NEW YORK REGIONAL INTERCONNECTION

**DEPARTMENT OF PUBLIC SERVICE (DPS)
INTERROGATORIES, DEFICIENCIES AND
STIPULATIONS
APPENDIX R**

Table 1. Department of Public Service (DPS), Interrogatory Description, Response Location and Witness Panel

Attachment for Interrogatory
DPS-4.10

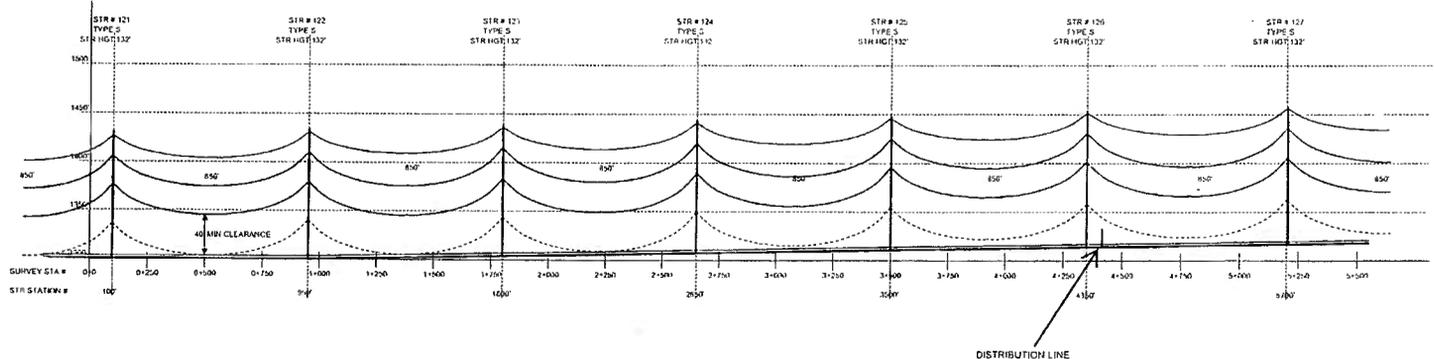
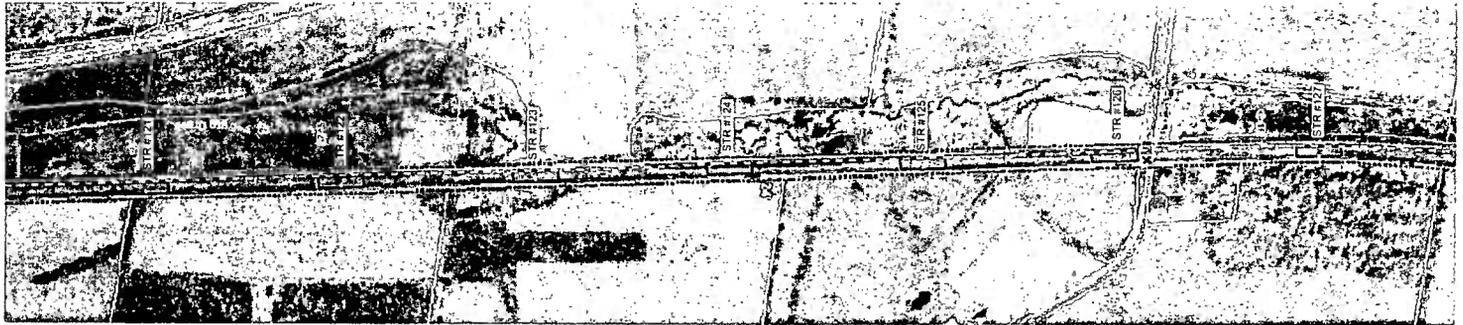
9. Provide lengths of these existing lines and proposed separation distances.	Separate	Panel E
	10. Provide a typical plan and profile drawing of the proposed EM&CP for a typical section along the New York Susquehanna & Western and Norfolk Southern Railroad ROW showing existing railroad, pole structure locations, vegetation clearing and trimming, property lines, piles of structure main members, and any other proposed construction sites.	Separate	Panel E

RAILROAD OWNER	TRANSMISSION LINE OWNER	KV	LINE LOCATION IN RELATION TO NYRI	APPROXIMATE STATION #	NYRI ROUTE TYPE (OH/UG)	BUFFER FROM RR Property line (ft)	LENGTH INTERFACING NYRI (miles)
GVTAR	NGrid L6	115	Adj. northeast	2	OH	100	0.80
NYS&W	NGrid L23/L29	46	Adj. west and east	5-6	UG	100	1.14
NYS&W	NGrid L23/L29	46	Adj. east and west	6-7	UG	100	0.40
NYS&W	NGrid L29	48	Adj. east	9-11	UG	100	1.99
NYS&W	NGrid L29	46	Adj. varies west and east	12-15	UG	100	2.24
NYS&W	Sherburne Muni	46	Adj. varies west and east and at times within RR Property	47-48	OH	100	0.89
Norfolk Southern	NYP&A	345	Intersects NYRI and RR which is 450 ft away	167	OH	100	1.10
Norfolk Southern	O&R	115	Intersects NYRI and adj. north	178	OH	100	0.47
Norfolk Southern	NYP&A	345	Adj. south, intersect NYRI	184-185	OH	100	0.73

**Attachment for Interrogatory
DPS-15.4**

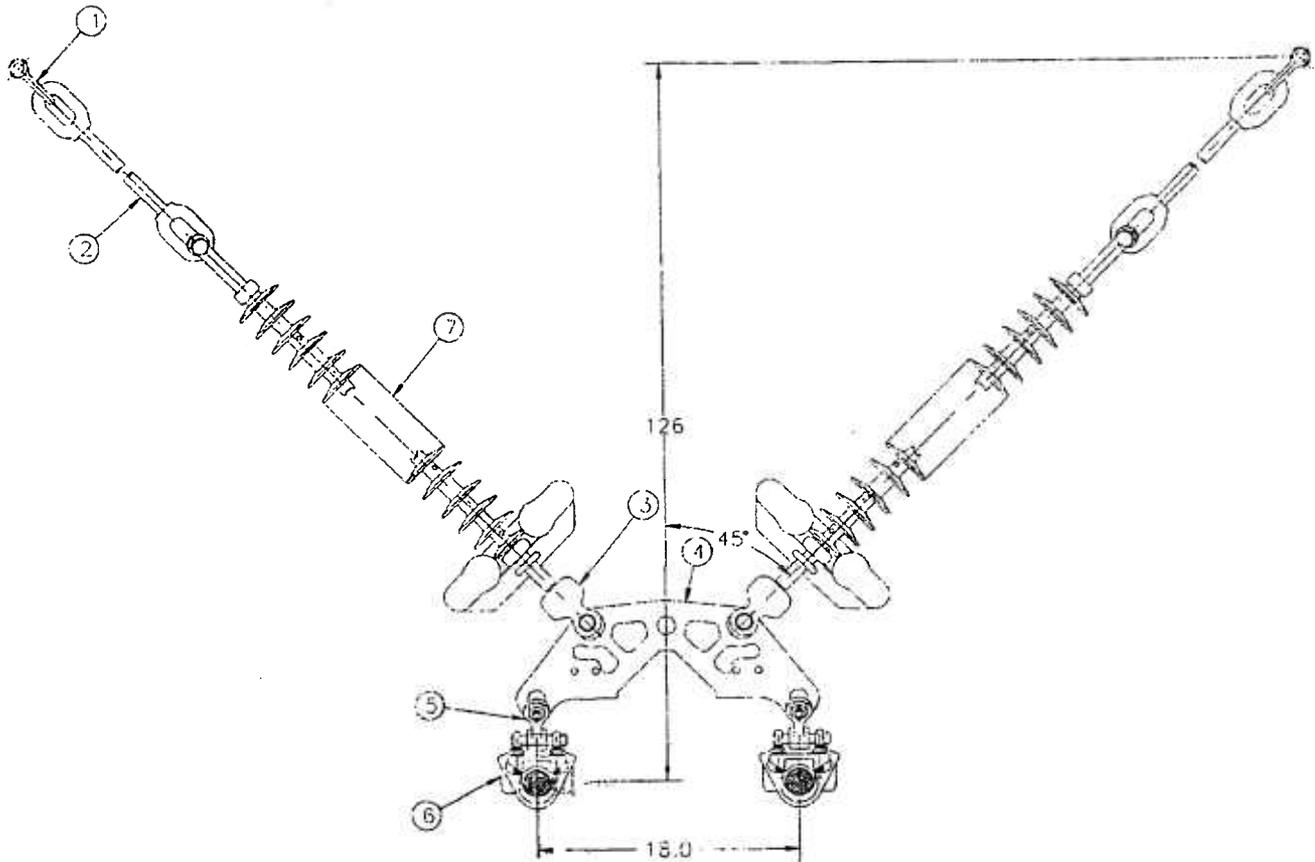
4. Provide a drawing showing all the typical hardware that will be used, include; the dimensions, the standard it is to be manufactured to, and possible finishes.	Separate	Panel D
DPS 16	1. To what ground resistance will the line be constructed?	Supplemental Article VII Application, Exhibit E-1.5.1	Panel D

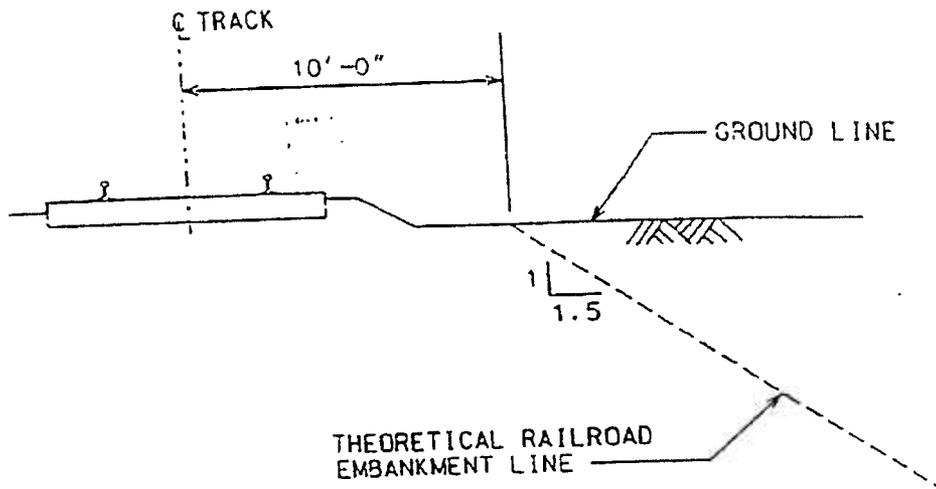
2. Provide the technical drawings of all caissons, embedded steel poles, etc showing the dimensions. (feet)	Supplemental Article VII Application, Exhibit E-1, Figs E-1.1.1-10 thru E-1.1.1-15	Panel D
DPS 22	1. Provide an engineering drawing of the counter poise system to be installed. Provide a written description of how the system will be installed. Explain how it is connected.	Supplemental Article VII Application, Exhibit E-1.5.2.2, Fig E-1.1.4-2	Panel D
DPS 23	1. Provide a copy of the railroad(s) specification(s) for occupancy in and along Railroad right-of-way.	Separate	Panel B

Section A, of the specifications entails the Sponsor's requirements for work affecting the railroad (pages 5 to 9). This section contains two drawings SK-1, Sheet Piling Adjacent to tracks as shown in Appendix A and drawing SK-2, Lateral Pressure due to Strip Load as shown in Appendix B.

Sheet piling shall be cut off at the top of tie during construction. After construction and backfilling has been completed, piling shall be cut off eighteen (18) inches below the existing ground line and left in place.

Attachment for Interrogatory
DPS-32.6

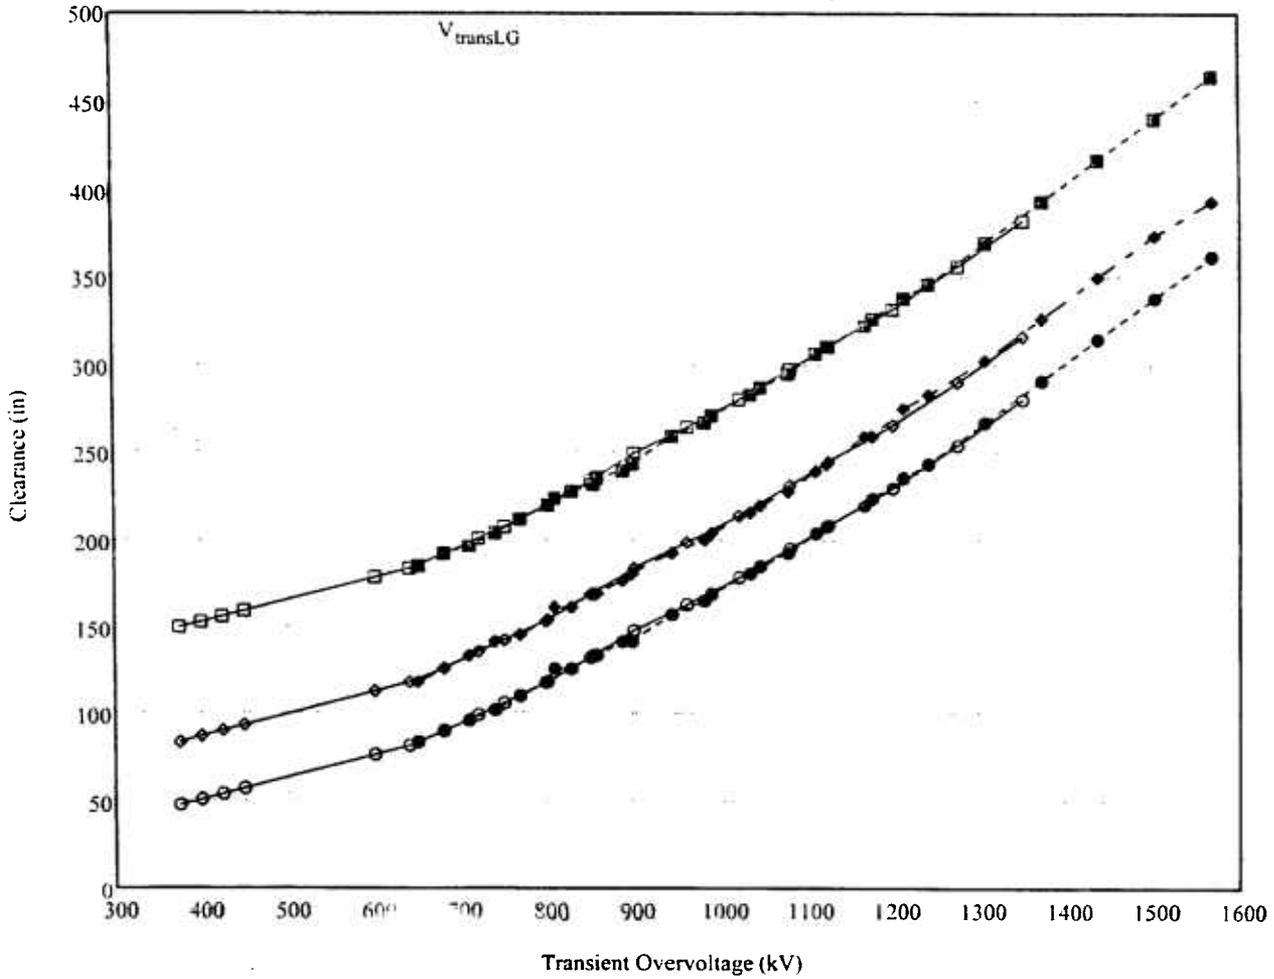
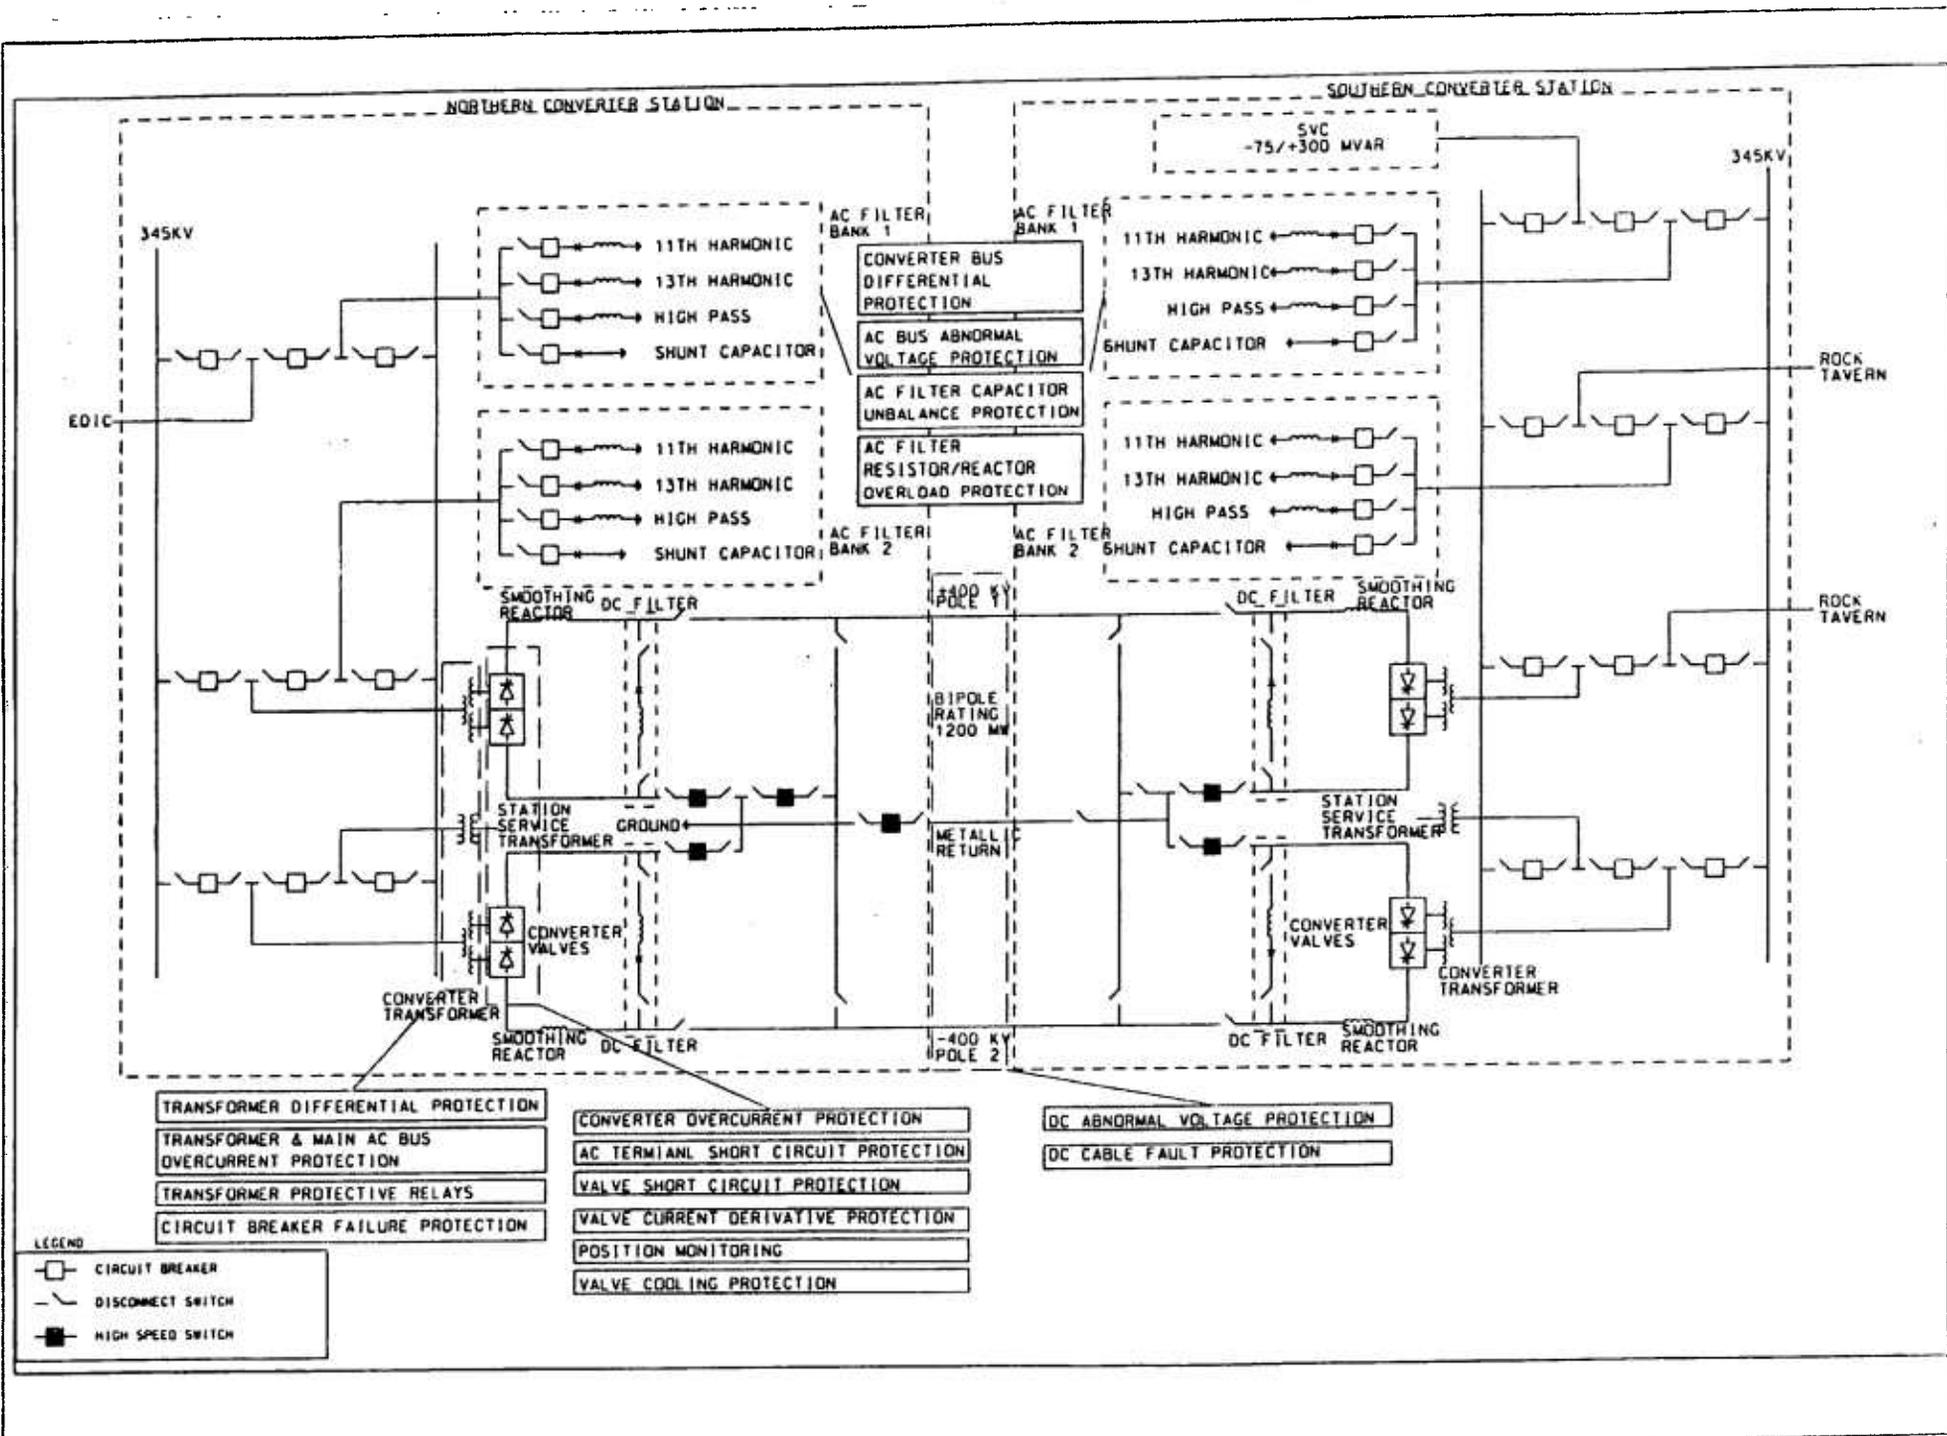
9. What is the outage time expected for the replacement of a valve? Supply copies of all supporting documents.	Separate	Panel D
	10. What are the applicant's plans for fire walls or barriers between major pieces of equipment? Supply copies of all supporting documents.	Separate & Supplemental Article VII Application, Exhibit E-2.2.6	Panel D

These figures are based on a total of 100 valve years from 1989 to 1994, and should represent state-of-the-art in the design of valves.
